**Subject:****CLICKING NOISE WHEN TURNING THE STEERING WHEEL****Bulletin No.: 08-004/23****Last Issued : 06/14/2023****BULLETIN NOTES****APPLICABLE MODEL(S)/VINS**

2019-2020 Mazda3 vehicles (Japan built) with VINs lower than JM1 BP\*\*\*\* \*\* 150801 (Produced before Aug. 5, 2019)

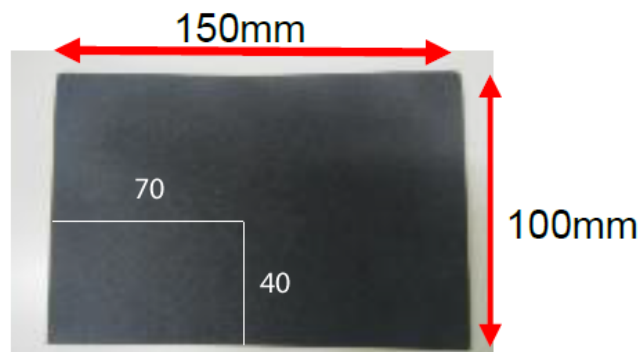
Some vehicles with the two-step deployment control air bag module may exhibit a clicking sound when turning the steering wheel. This is caused by the horn spring (1) of the airbag module interfering with the black color tape (2) of the clock spring harness (3), resulting in a stick-slip noise (click on attached sound file below).

To eliminate this concern, a material change of the harness tape is planned.

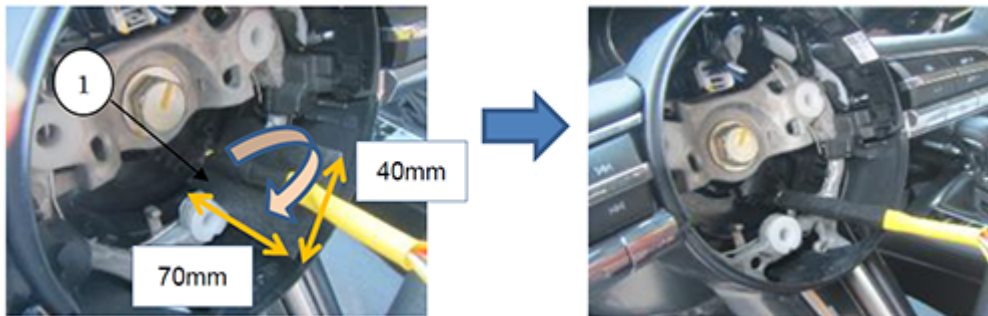
4. Wrap the clock spring harness from its root with the urethane tape (1) in order to cover the black color tape that is covering the harness.

**NOTE:** There is no need to cover the entire black color tape with the urethane tape in case the black color tape is longer than the urethane tape. The designated urethane tape length is enough to avoid clicking noise.

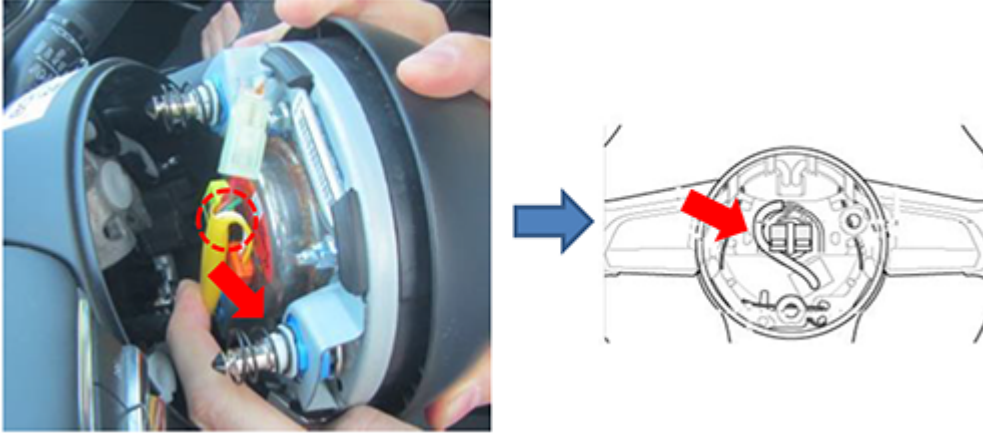
5. Reinstall the driver side module according to the instructions on MGSS (DRIVER-SIDE AIR BAG MODULE INSTALLATION [TWO-STEP DEPLOYMENT CONTROL SYSTEM - US/CANADA SPEC.]

**NOTE:** DO NOT route the air bag harness between the air bag connectors. Route the harness outside of the connectors as detailed by the red arrow.
